#### 193rd session

## Proposal for Supplement 2 to the 03 series of amendments to UN Regulation No. 117 (Tyre rolling resistance, rolling noise and wet grip)

### Submitted by the Working Party on Noise and Tyres\*

Figure 1  
**Nomenclature explanation related to grip index of the tyre**

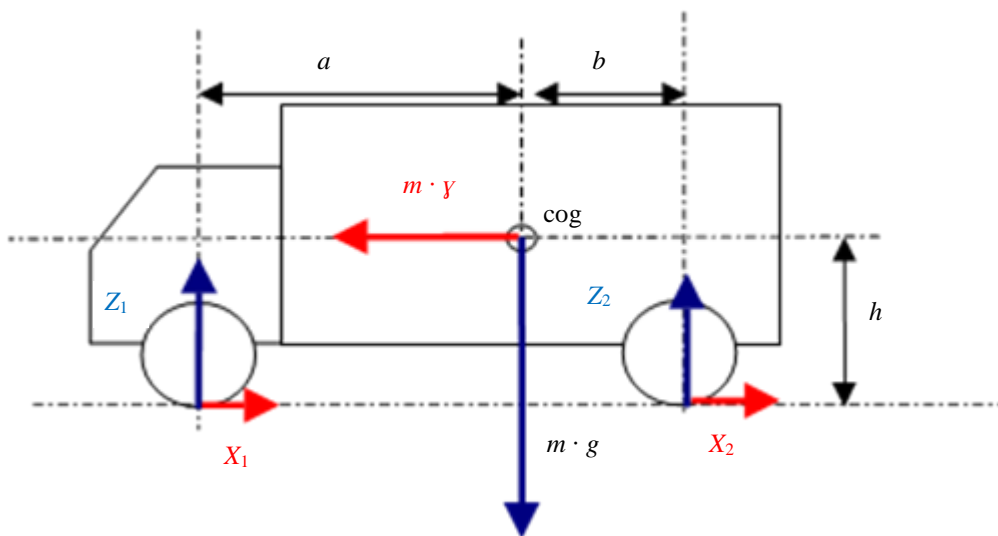
"2.2.2.7.5. Calculation of the relative wet grip index of the tyre

The wet grip index represents the relative performance of the candidate tyre compared to the reference tyre. The way to obtain it depends on the test configuration as defined in paragraph 2.2.2.2. of this Annex. The wet grip index  $G$  of the tyre is calculated as reported into Table 7:

Configuration C1: candidate tyres on both axles	$G = f \cdot \frac{BFC(T)}{BFC(R)}$
Configuration C2: candidate tyres on front axle and reference tyres on rear axle	$G = f \cdot \frac{BFC(T) \cdot [a+b+h \cdot BFC(R)] - a \cdot BFC(R)}{BFC(R) \cdot [b+h \cdot BFC(T)]}$
Configuration C3: reference tyres on front axle and candidate tyres on rear axle	$G = f \cdot \frac{BFC(T) \cdot [-a-b+h \cdot BFC(R)] + b \cdot BFC(R)}{BFC(R) \cdot [-a+h \cdot BFC(T)]}$

Where (see also Figure 1):

- $f$ : correction factor depending on used SRTT
  - $cog$ : centre of gravity of the loaded vehicle
  - $m$ : mass (in kilograms) of the loaded vehicle
  - $a$ : horizontal distance between front axle and centre of gravity of the loaded vehicle (m)

- $b$ : horizontal distance between rear axle and centre of gravity of the loaded vehicle
  - $h$ : vertical distance between ground level and centre of gravity of the loaded vehicle (m).

- N.B.* When  $h$  is not precisely known, these worst case values shall apply: 1.2 for configuration C2, and 1.5 for configuration C3
- $\gamma$ : loaded vehicle acceleration [ $m \cdot s^{-2}$ ]

Figure 1

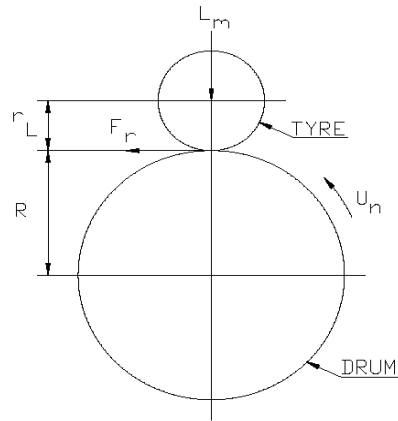
"4.5. Measurement and recording

The following shall be measured and recorded (see Figure 1):

- (a) Test speed  $U_n$ ;
- (b) Load on the tyre normal to the drum surface  $L_m$ ;
- (c) The initial test inflation pressure as defined in paragraph 3.3. above;
- (d) The coefficient of rolling resistance measured  $C_r$ , and its corrected value  $C_{rc}$ , at 25 °C and for a drum diameter of 2 m;
- (e) The distance from the tyre axis to the drum outer surface under steady state  $r_L$ ;
- (f) Ambient temperature  $t_{amb}$ ;
- (g) Test drum radius R;

- (h) Test method chosen;
- (i) Test rim (size and material);
- (j) Tyre size, manufacturer, type, identity number (if one exists), speed category symbol, load index, DOT number (Department of Transportation).
